**Re: Van H. Gilbert Office Addition, 2428 Baylor Dr. SE,
Certificate of Occupancy – Transportation Development
Engineer's Stamp dated 7-16-08 (M16-D012)
Certification dated 02-06-09**

RE: **VAN H. GILBERT ARCHITECT STUDIO OFFICE ADDITION (M16 - D012)**
Revised Grading and Drainage Plan (PE Stamped 04-11-08)

RE: VAN GILBERT ARCHITECT STUDIO OFFICE ADDITION (M16-D012) GRADING
AND DRAINAGE PLAN

RE: **VAN H. GILBERT ARCHITECT STUDIO OFFICE ADDITION (M16 - D012)**
Grading and Drainage Plan (PE Stamped 02-05-08)

CONSTORM™ Calculator

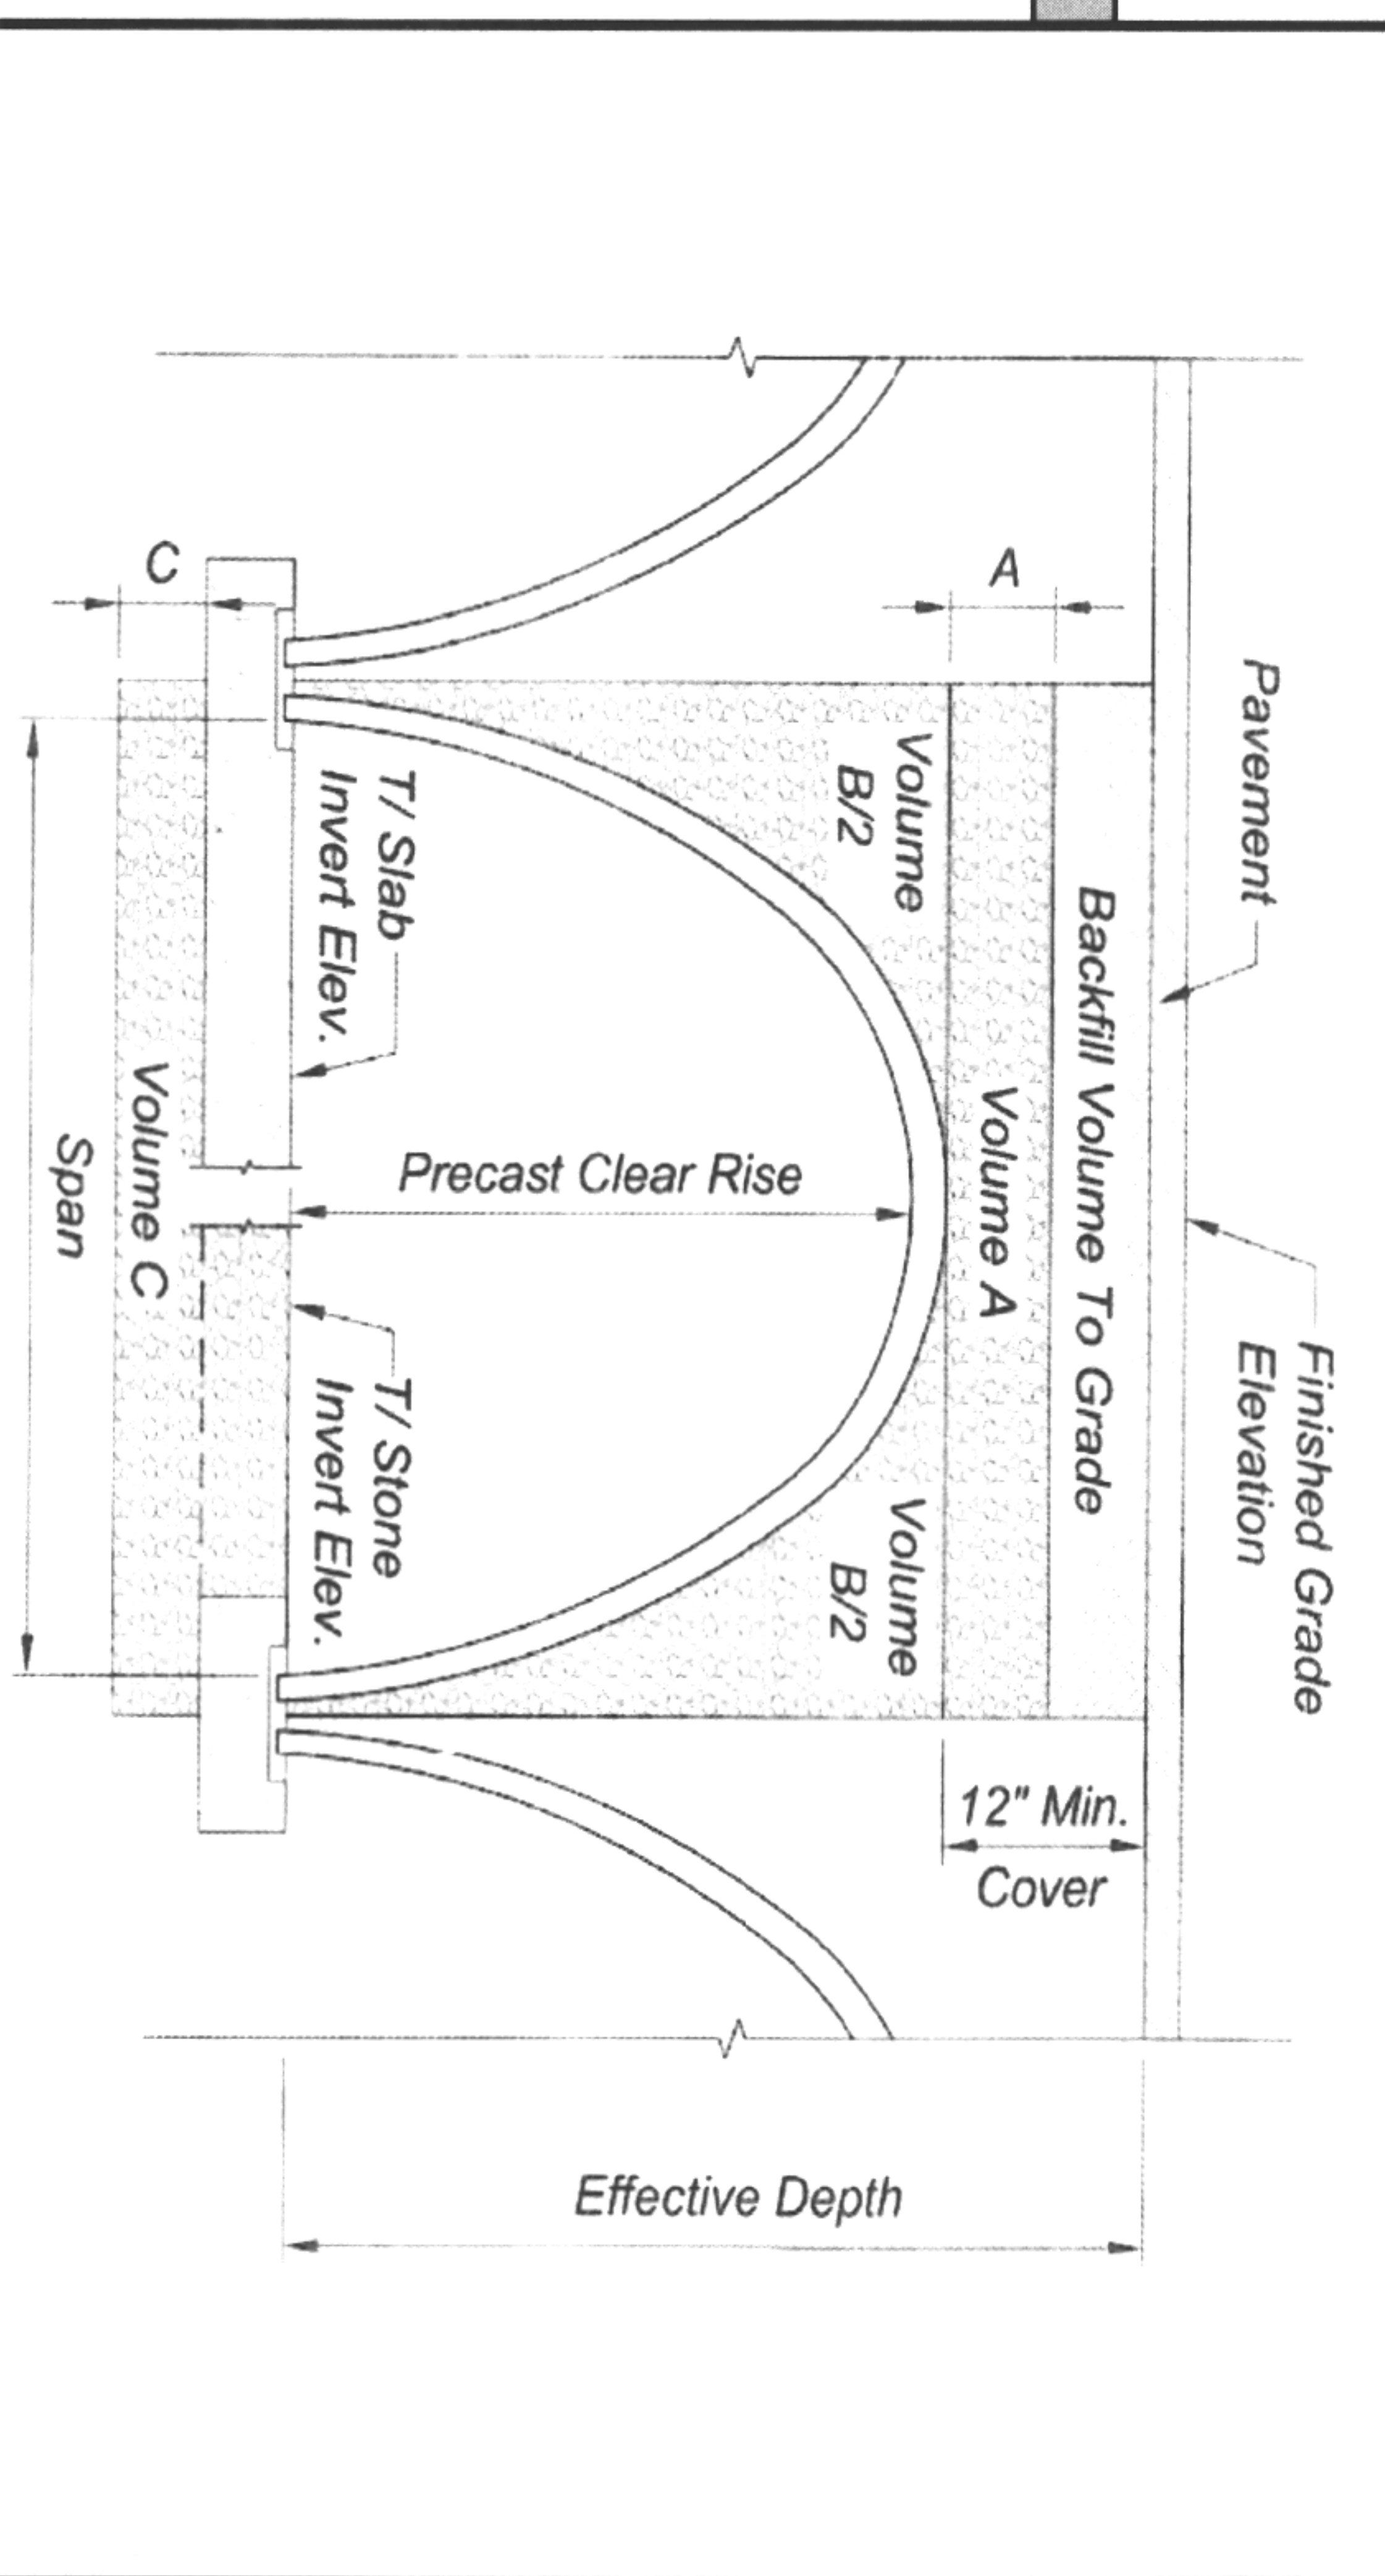
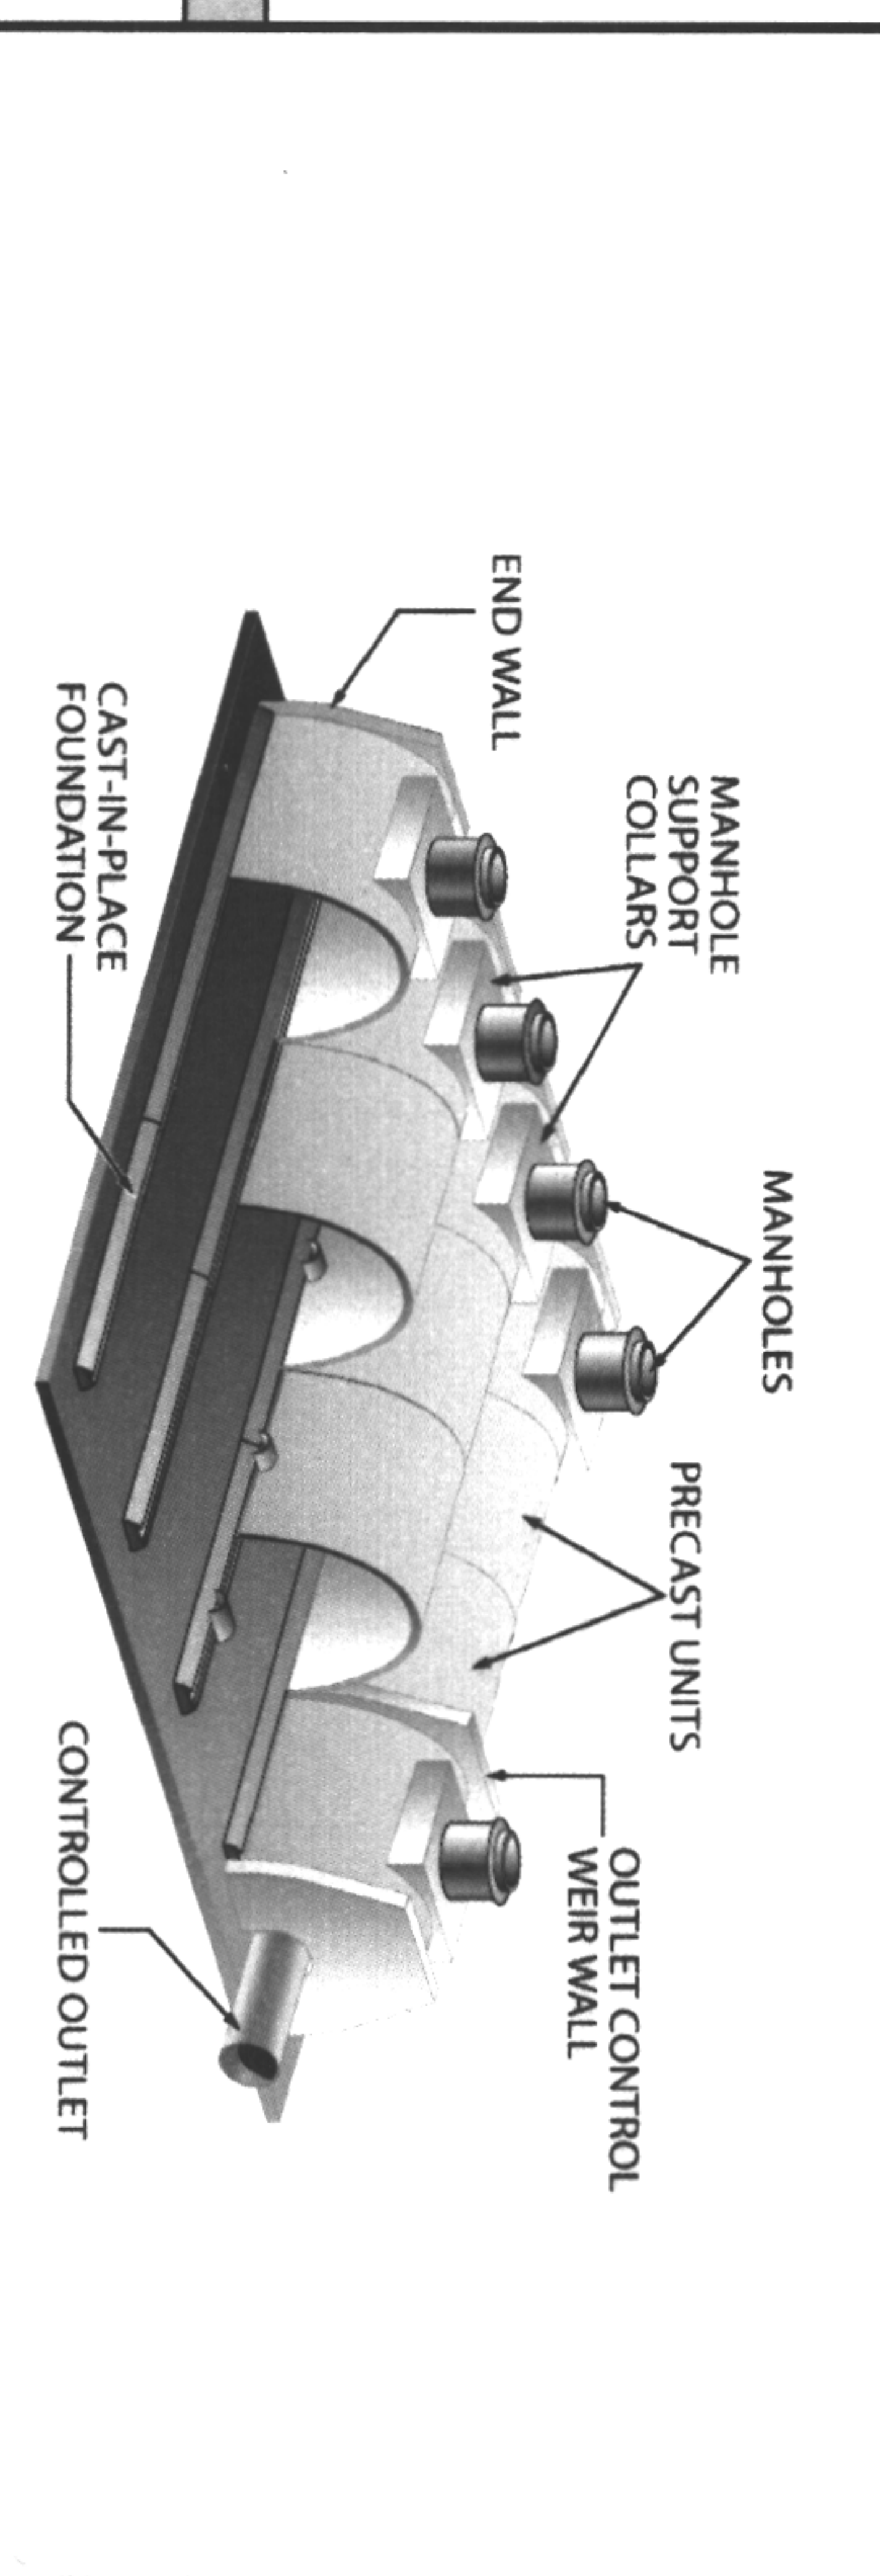
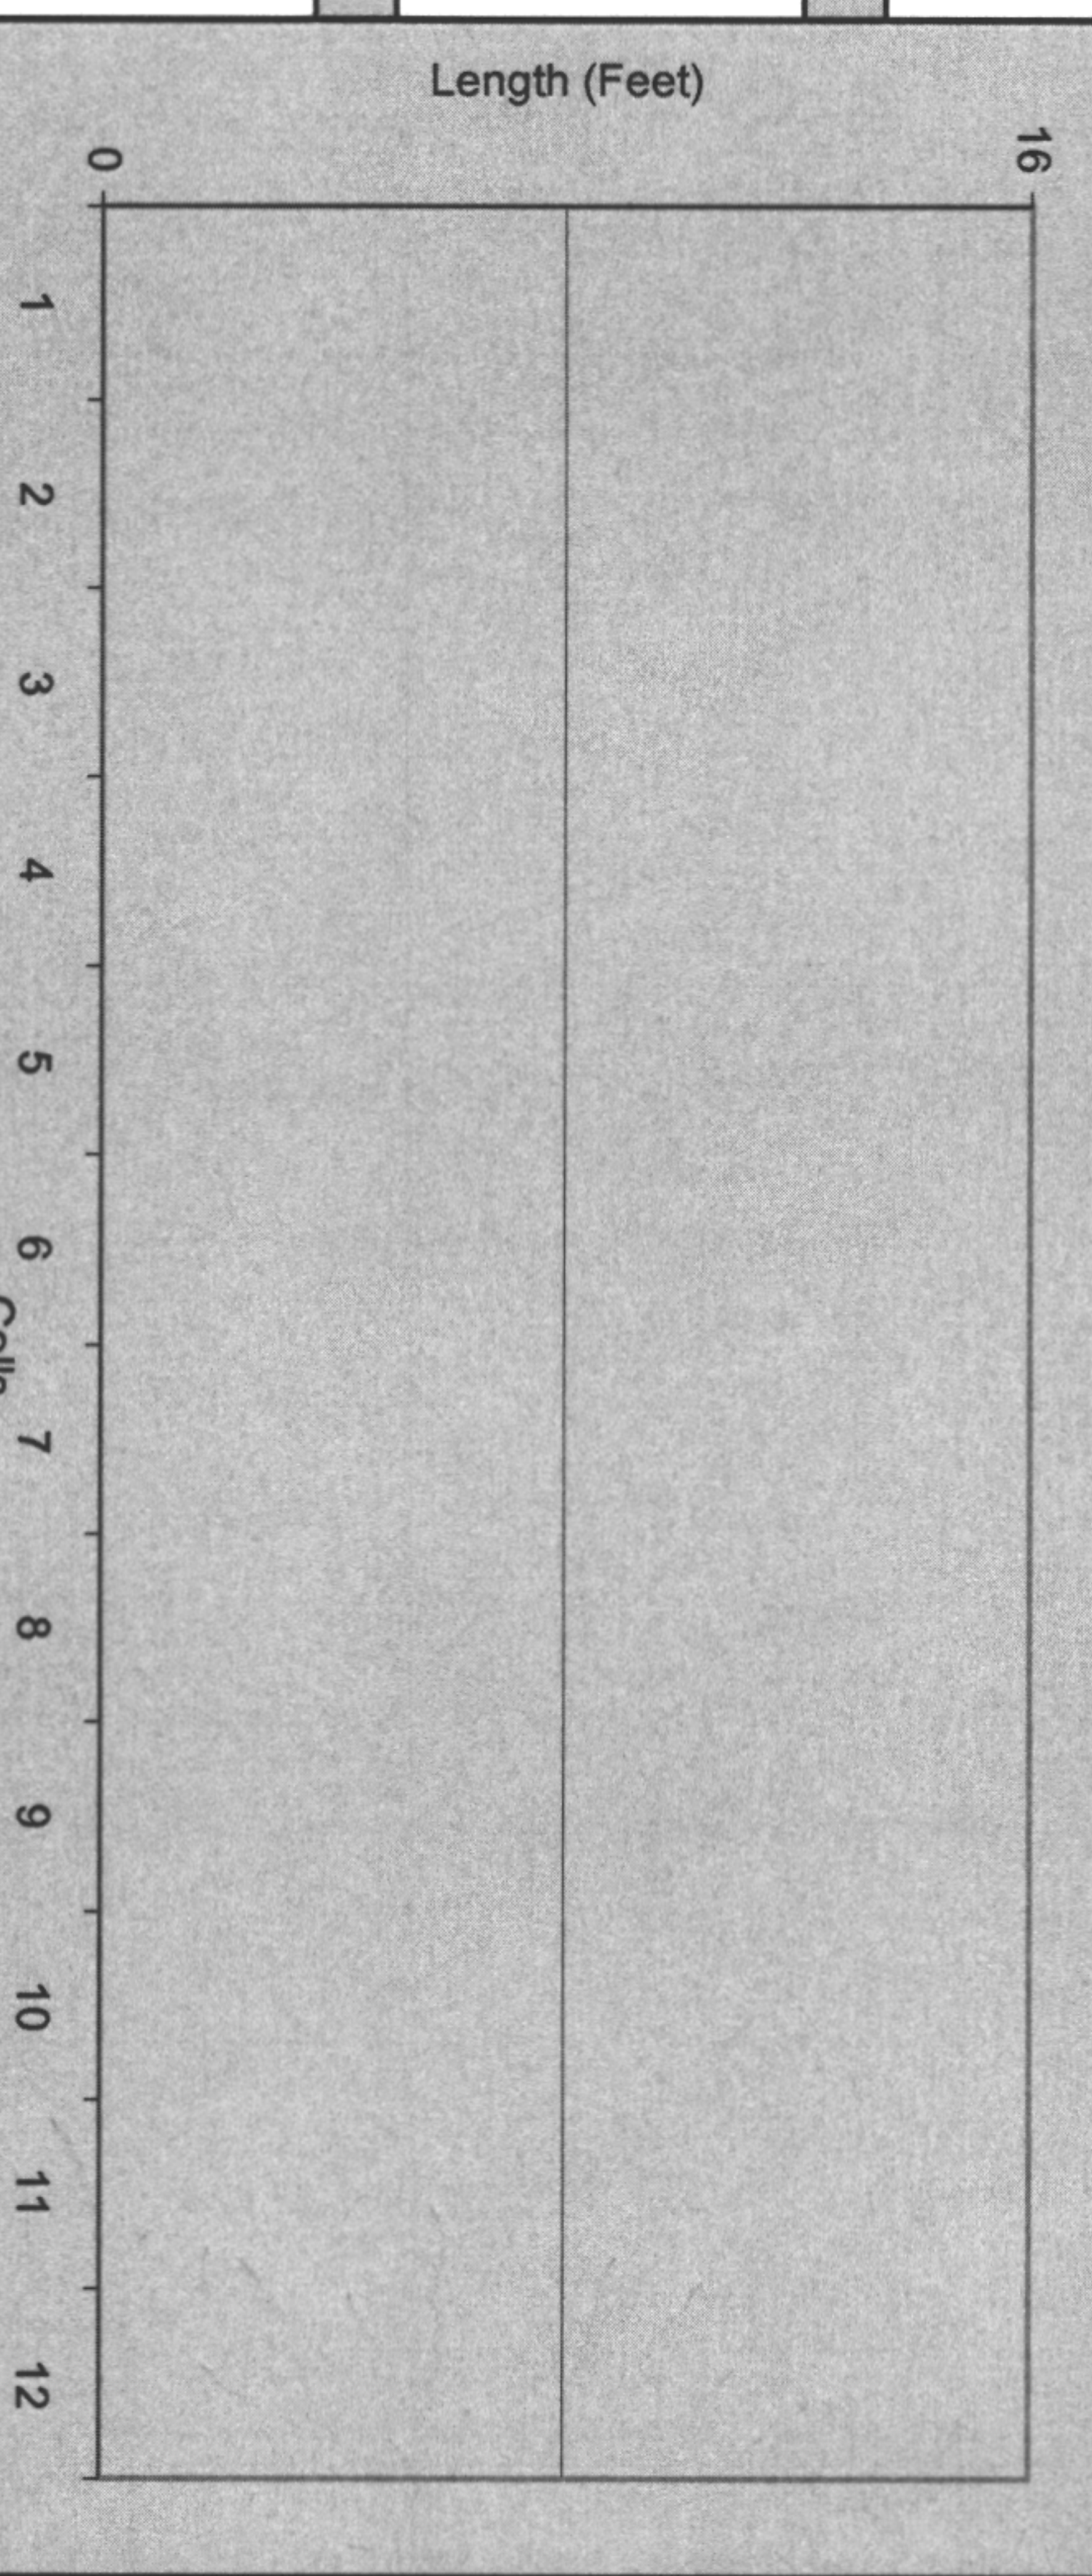
only need 6,265 cf of 2x6's
